Access Compliance Report

Public Rights-of-Way

(Curb Ramps)

Intersection ID: 27062	Main Street: ESHERWOOD_LN	Cross Street: PROVIDENCE_ARBOURS_DR	Location:	N
ADA ID: E15851ADFE21	Ramp Type: Perp	Initial Pass/Fail: Fail	Overall Compliance: No	Severity Score: 35
Codes/Mitigation Info/Possible Solution		Field Measurements/Component Compliance

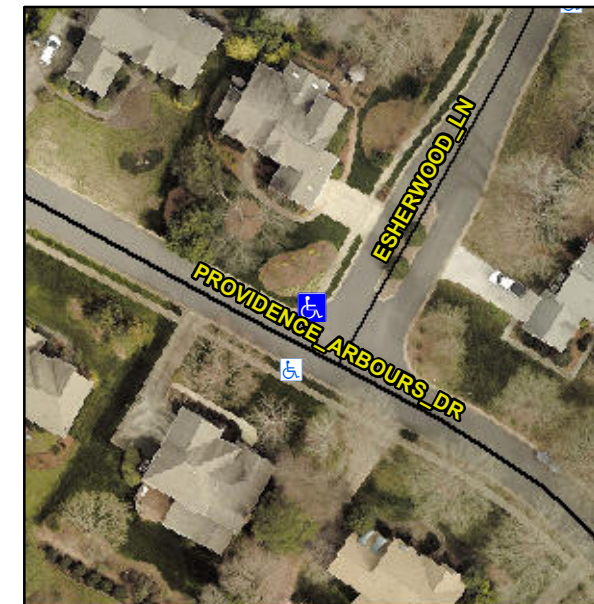
Not Found, R304.5.1

Compliance	Description	Data	Compliance	Description	Data
N/A	Ramp Length (in)	27.0	Yes	Ramp Slope (%)	7.2
No	Ramp Width (in)	29.0	Yes	Ramp XSlope (%)	1.0
N/A	Flare Type LT	N/A	N/A	Flare Type RT	N/A
N/A	Flare Slope LT (%)	N/A	N/A	Flare Slope RT (%)	N/A
N/A	Flare Traversable LT?	N/A	N/A	Flare Traversable RT?	N/A
N/A	Landing Length (in)	N/A	N/A	DWS Provided?	N/A
N/A	Landing Width (in)	N/A	N/A	DWS Contrast?	N/A
N/A	Landing Slope (%)	N/A	N/A	DWS Length (in)	N/A
N/A	Landing X Slope (%)	N/A	N/A	DWS Full Width?	N/A
N/A	Landing Curb? (Y/N)	N/A	N/A	DWS Offset (in)	N/A
N/A	Shared Landing?	N/A			
N/A	Gutter Ponding?	N/A	N/A	Gutter Slope (%)	N/A
N/A	Gutter Lip Ht (in)	N/A	N/A	Gutter X Slope (%)	N/A
N/A	Painted X Walk1?	No	N/A	Painted X Walk2?	N/A
	X Walk 1 Direction	To SW		X Walk 2 Direction	N/A
N/A	X Walk 1 Width (in)	N/A	N/A	X Walk 2 Width (in)	N/A
	X Walk 1 Slope (%)	2.3		X Walk 2 Slope (%)	N/A
	X Walk 1 X Slope (%)	0.5		X Walk 2 X Slope (%)	N/A

Remove & Replace Entire Ramp.
